Service Advisory

W-148

ZT SERIES

Subject: Service Replacement Hydro Transmissions 759-04142 & 759-04143

FIGURE 1

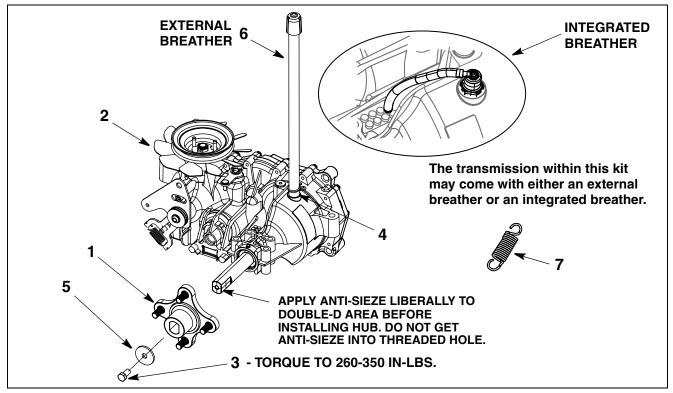
PURPOSE: This service kit replaces the LH hydro transmissions 618-04164A and 618-04327 which are no longer available. The replacement transmission has a Double-D axle end which requires a Double-D wheel hub assembly. A new neutral return spring is enclosed for the RH transmission. See instructions on page 2 of this sheet.

ITEM	PART	QTY	DESCRIPTION
NO.	NUMBER		
1	618-04494	1	HUB ASM:WHL:DOUBLE-D SHORT
2	618-04431A	1	TRANS ASM:HYDRO:EZT:LH
3	710-3119	1	SCREW:3/8"-16 x .750:GR5:LOCK
4	726-04059	1	CLAMP:HOSE: .750
5	736-0227	1	WASHER:FLAT: .390 x 1.50 x .134
6	751-10474	1	HOSE: BREATHER: EXTERNAL
7	732-04448	1	SPRING: EXTENSION (See page 2)
8	*	1	THIS INSTRUCTION SHEET

FIGURE 2

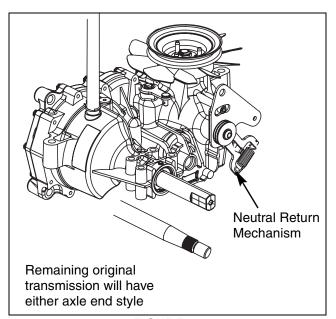
- 1. A Neutral Return Extension Spring, Item 7, is supplied with this kit for installation on the remaining hydrostatic transmission when only one hydrostatic transmission is being replaced.
- 2. This spring, Item 7, must be installed on the remaining hydrostatic transmission in order for both transmissions to come to neutral at the same rate.
- 3. See Figure 2 for location of the neutral return mechanism.

4. With a suitable set of pliers or spring removal tool, remove and discard the existing spring from the neutral return mechanisms two arms on the remaining (not replaced with this kit) hydrostatic transmission. See Figure 3.

- 5. Install the new Neutral Return Spring, Item 7, onto the two as shown in Figure 3.
- 6. When complete both installed transmissions must have the same color neutral return spring.
- 7. This completes the installation of the new Neutral Return Spring onto the remaining original transmission.

FIGURE 1

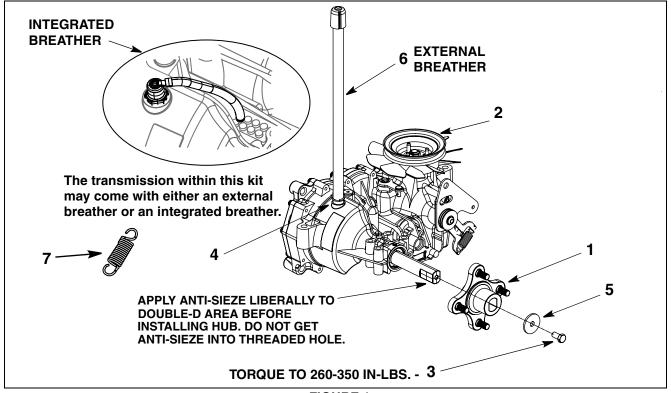
PURPOSE: This service kit replaces the RH hydro transmissions 618-04163A and 618-04326 which are no longer available. The replacement transmission has a Double-D axle end which requires a Double-D wheel hub assembly. A new neutral return spring is enclosed for the LH transmission. See instructions on page 2 of this sheet.

ITEM	PART	QTY	DESCRIPTION
NO.	NUMBER		
1	618-04494	1	HUB ASM:WHL:DOUBLE-D SHORT
2	618-04432A	1	TRANS ASM:HYDRO:EZT:RH
3	710-3119	1	SCREW:3/8"-16 x .750:GR5:LOCK
4	726-04059	1	CLAMP:HOSE: .750
5	736-0227	1	WASHER:FLAT: .390 x 1.50 x .134
6	751-10474	1	HOSE: BREATHER: EXTERNAL
7	732-04448	1	SPRING: EXTENSION (See page 2)
8	*	1	THIS INSTRUCTION SHEET

FIGURE 2

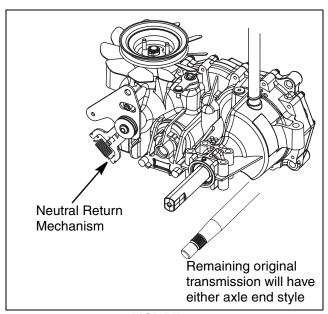
- 1. A Neutral Return Extension Spring, Item 7, is supplied with this kit for installation on the remaining hydrostatic transmission when only one hydrostatic transmission is being replaced.
- 2. This spring, Item 7, must be installed on the remaining hydrostatic transmission in order for both transmissions to come to neutral at the same rate.
- 3. See Figure 2 for location of the neutral return mechanism.

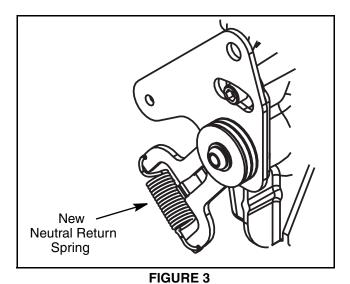
4. With a suitable set of pliers or spring removal tool, remove and discard the existing spring from the neutral return mechanisms two arms on the remaining (not replaced with this kit) hydrostatic transmission. See Figure 3.

- 5. Install the new Neutral Return Spring, Item 7, onto the two arms as shown in Figure 3.
- 6. When complete both installed transmissions must have the same color neutral return spring.
- 7. This completes the installation of the new Neutral Return Spring onto the remaining original transmission.
